RE: Submittal of the final Value Engineering Report  
Project No.: NH-051-1(25)  
County: Clarke  
P.I. No.: 122850  
SR 10 Loop  
PBS&J Project Task Order No. 30

# ***Value Engineering Study Report***

***Project – NH-051-1(25)***

***SR 10 Loop***

ALTERNATIVE NO.:  
**BR-5**

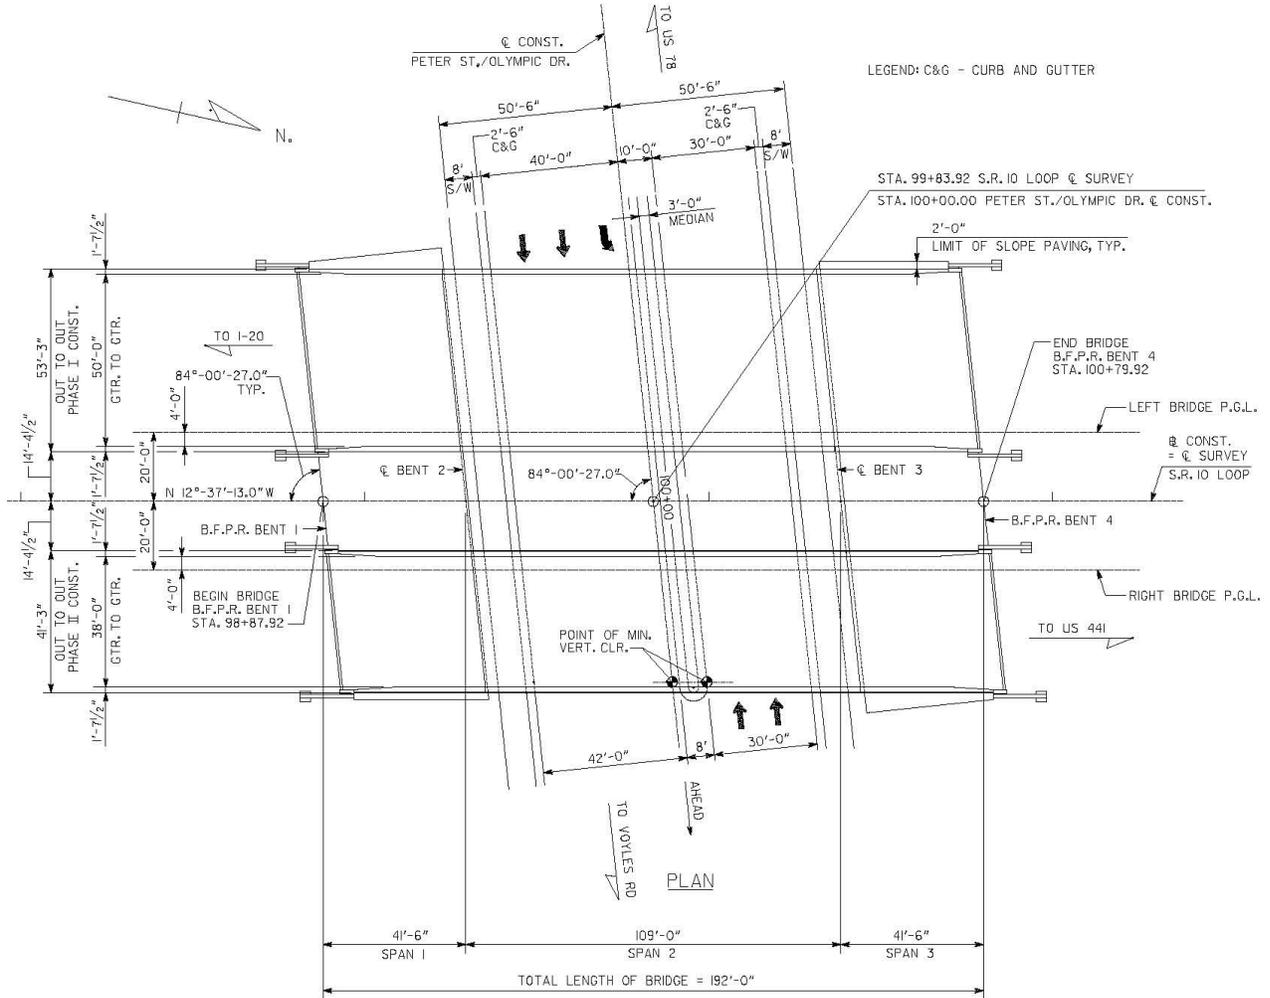
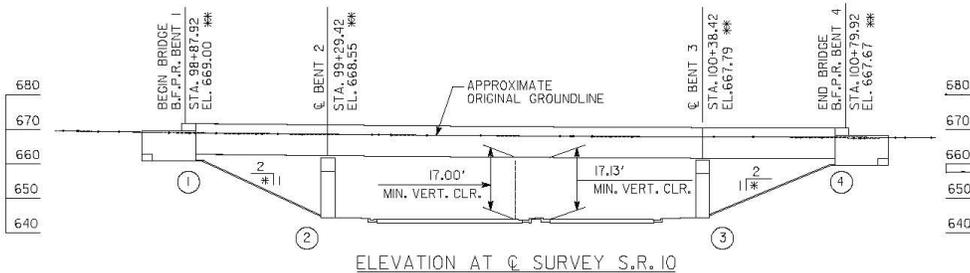
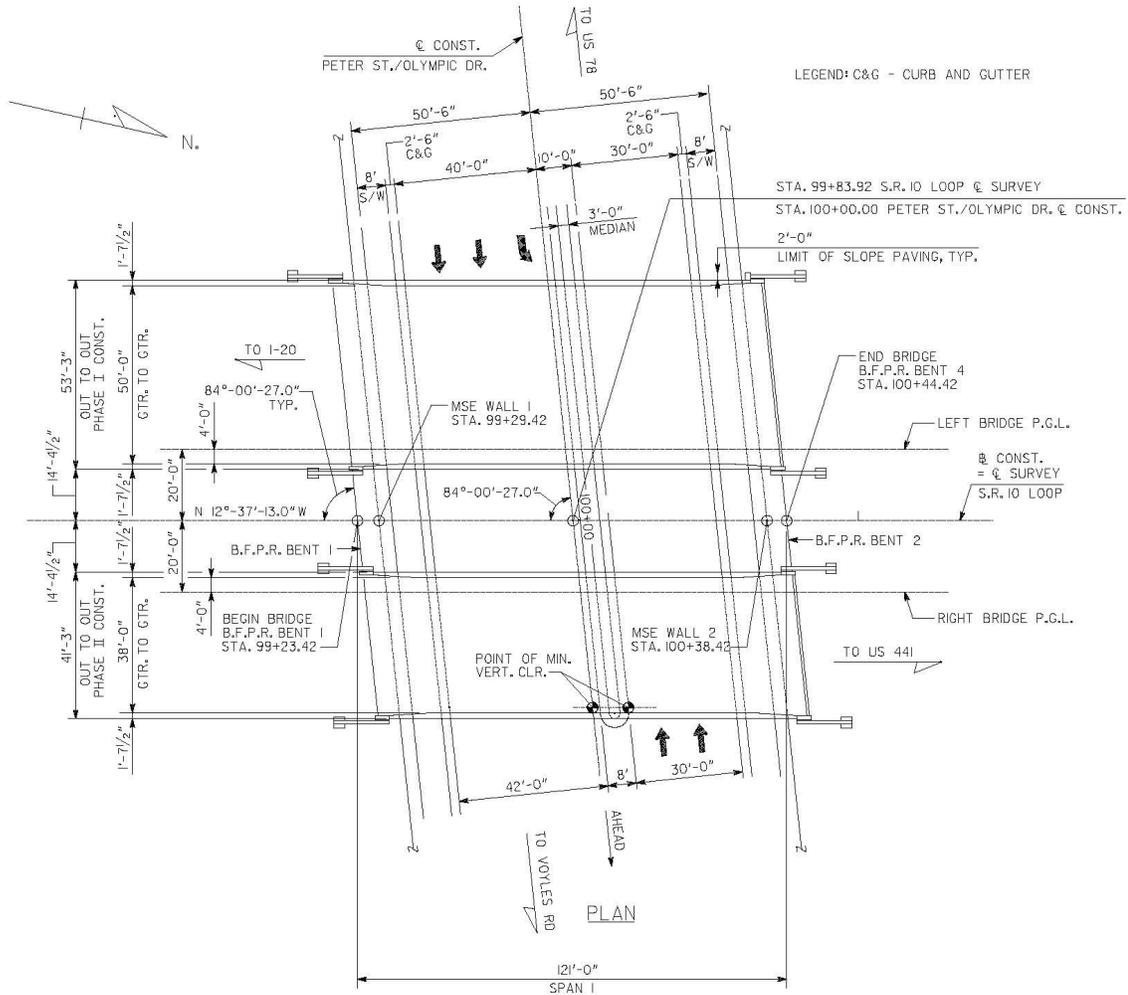
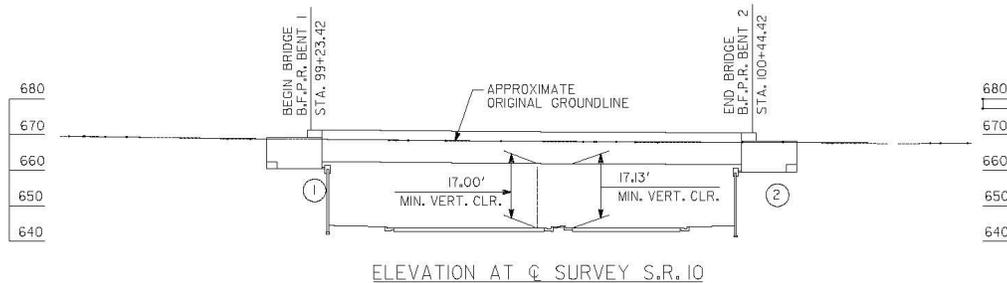
PROJECT:	<b>Georgia Department of Transportation NH-051-1(25) – P.I. 122850 SR 10 Loop - Clarke County</b>	ALTERNATIVE NO.:	<b>BR-5</b>
DESCRIPTION:	<b>Use MSE Walled Abutments to accommodate Single Span Bridges</b>	SHEET NO.:	<b>1 of 6</b>

ALTERNATIVE BR-8

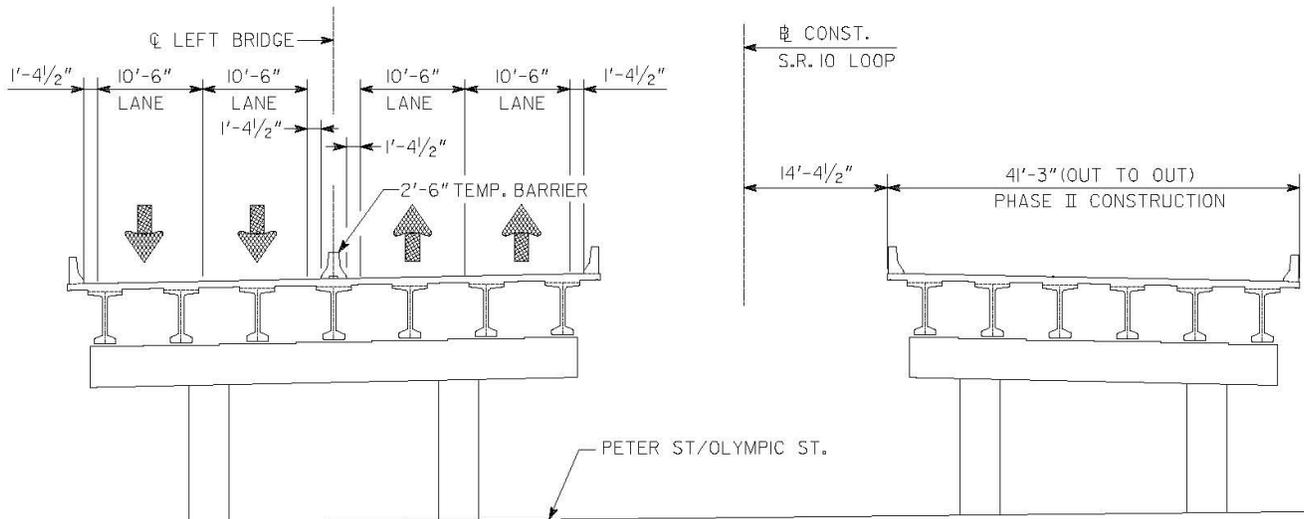
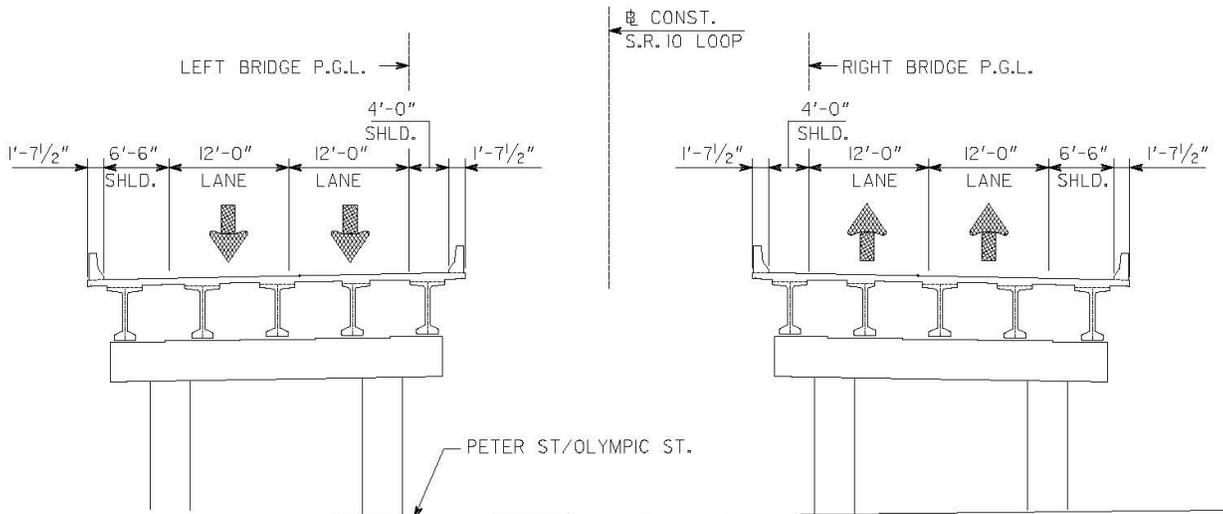
The proposed alternative, in conjunction with Alternative AP-21, includes a redesigned interchange and Maintenance of Traffic Plan resulting in eliminating one lane (turn lane) on the West Bridge. Additionally, the shoulders are reduced in width (4' inside and 6'-6" outside on both bridges) to match the SR 10 Loop cross section.

Interchange redesign and revised Maintenance of Traffic Plan will be required to facilitate the reduction in the bridge widths. Both bridges (East & West) are similar in all aspects in dimensions.

ALTERNATIVE BR-9

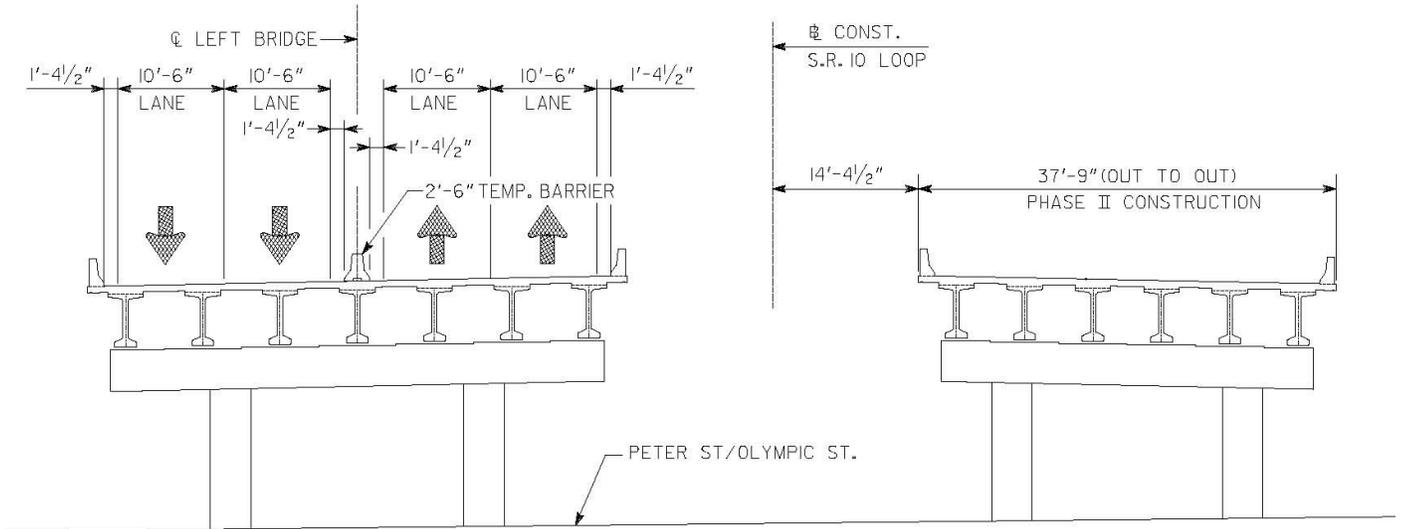
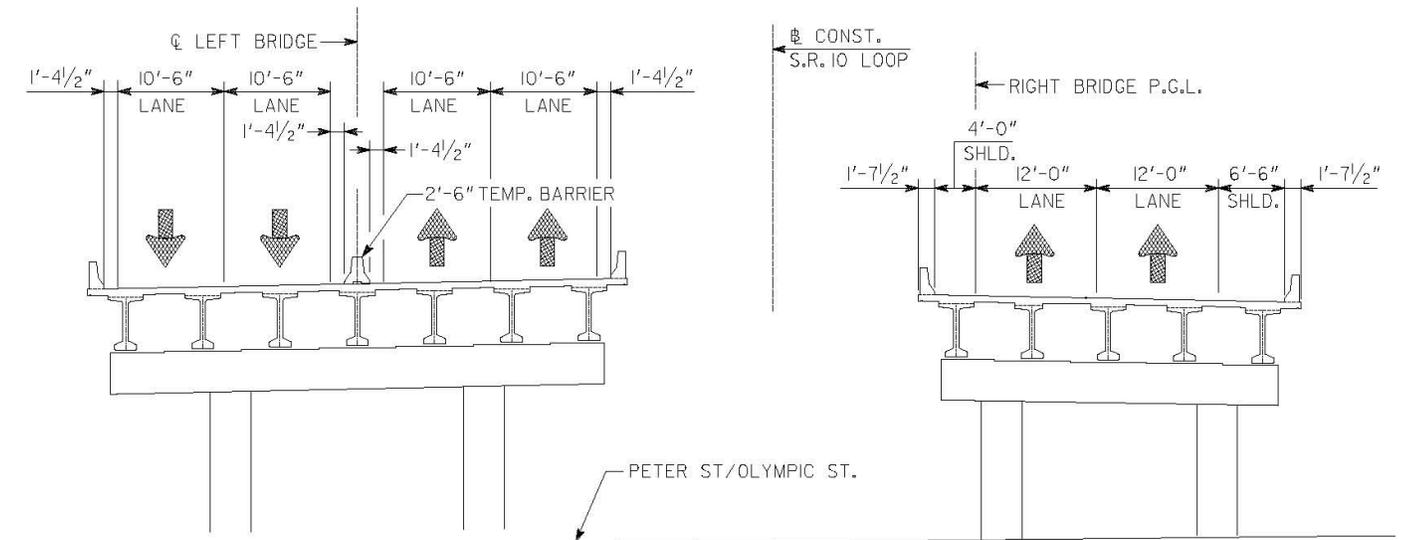
The same number of beams may be required for the revised cross section as in the current design. Savings will be on the deck slab only.

ALTERNATIVE NO.:  
**EW-7**

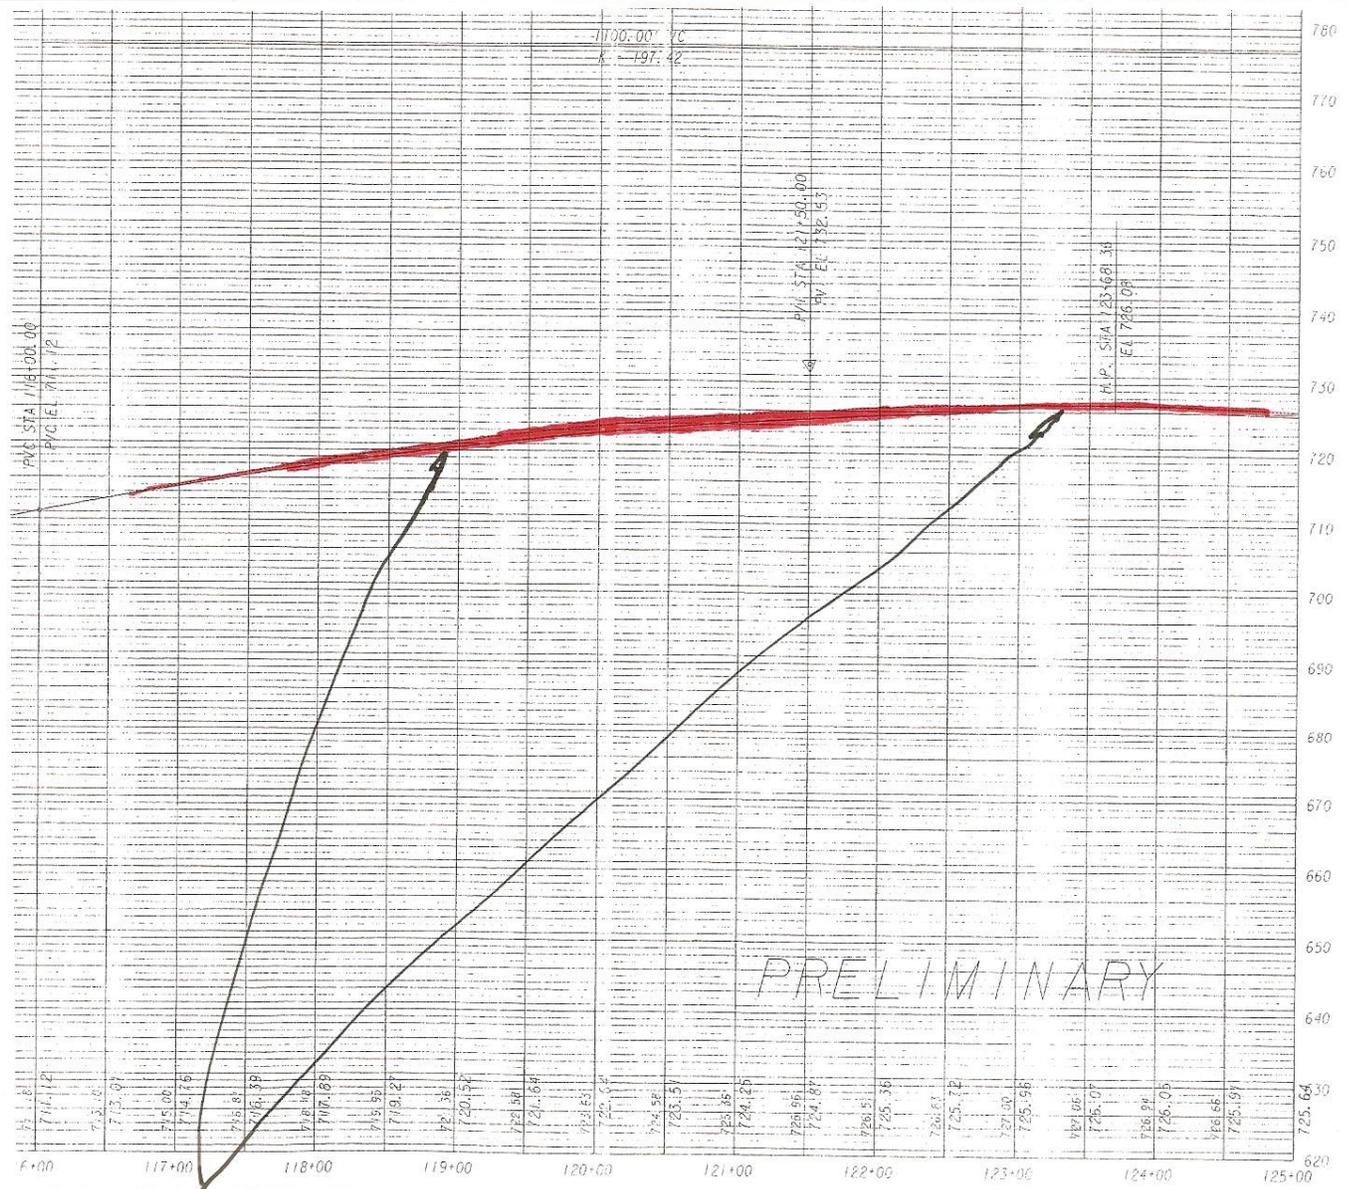
The SR 10 Loop is currently posted at a 55 MPH speed limit. The roadway is supposedly designed for 65 mph, however, there is at least one portion (just north of this intersection) which appears to be designed for less than 65 mph. The current project plan calls for adjusting the grade of the existing roadway by doing a vertical grade correction consisting of a revising the existing 1,100' vertical curve, **to lower its profile grade line by only 2'**. Cost savings include full build-up of asphalt and GAB for roadway and shoulders that will not have to be removed and replaced using the alternative. From inspection of the existing “loop” road, it does not appear reasonable to believe that one would ever consider raising the speed limit on this roadway. Additionally, the entire roadway has substandard shoulders and probably other significant deficiencies which might be addressed before doing a minor (major cost) adjustment of an existing grade.
